APPALACHIAN MOUNTAIN ADVOCATES

February 13, 2015

RE: Comments on Special Use Application submitted by Atlantic Coast Pipeline, LLC

Atlantic Coast Pipeline
Figure 10.4-1
System Alternatives

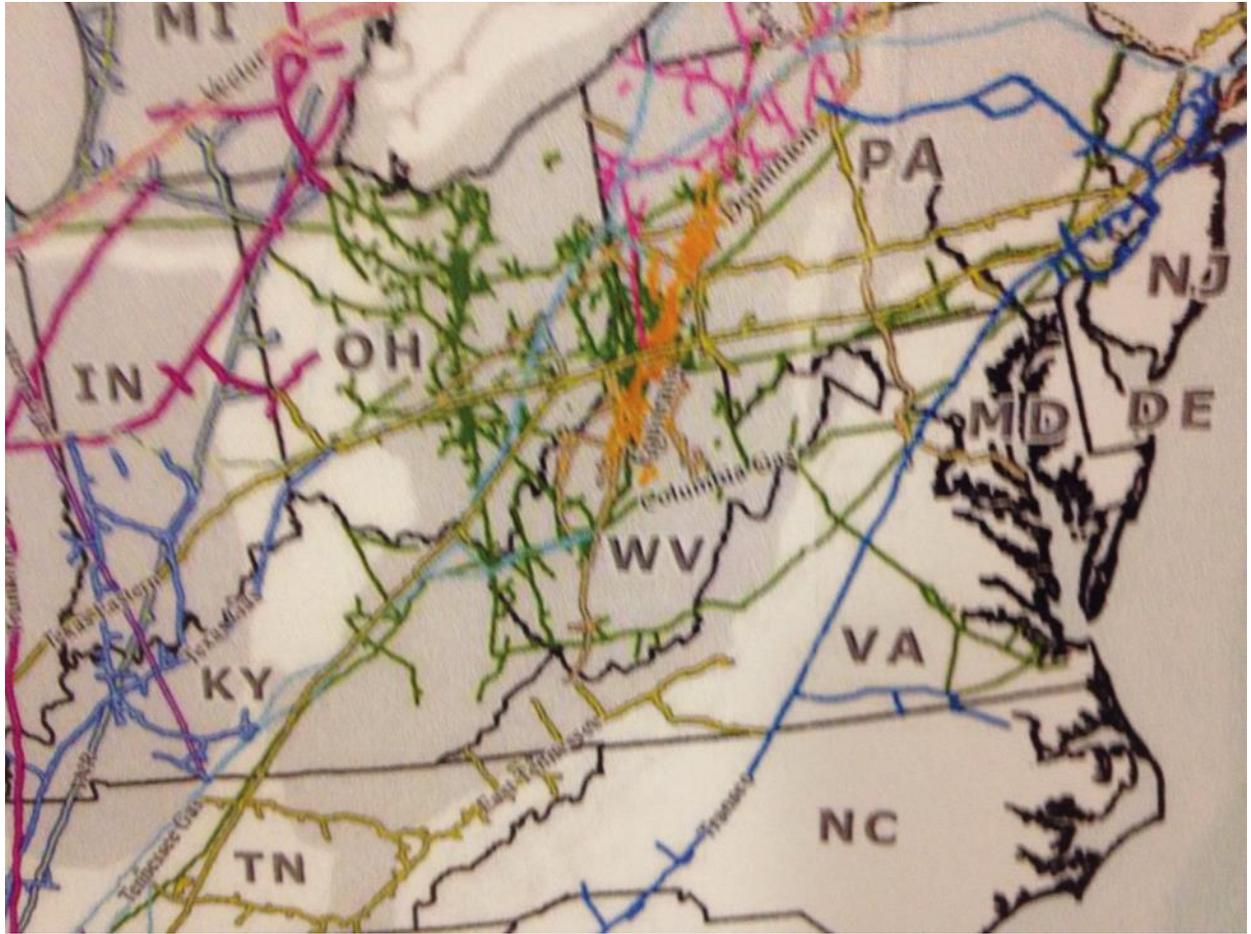
Several existing pipeline corridors already connect the "Marcellus region" to the Southeast. See Exhibit A (Dominion Map of "System Alternatives", Resource Report 10, Table

10.4-1, submitted to FERC December 2014) (showing proposed routes of several pipelines). Each of these merits consideration.
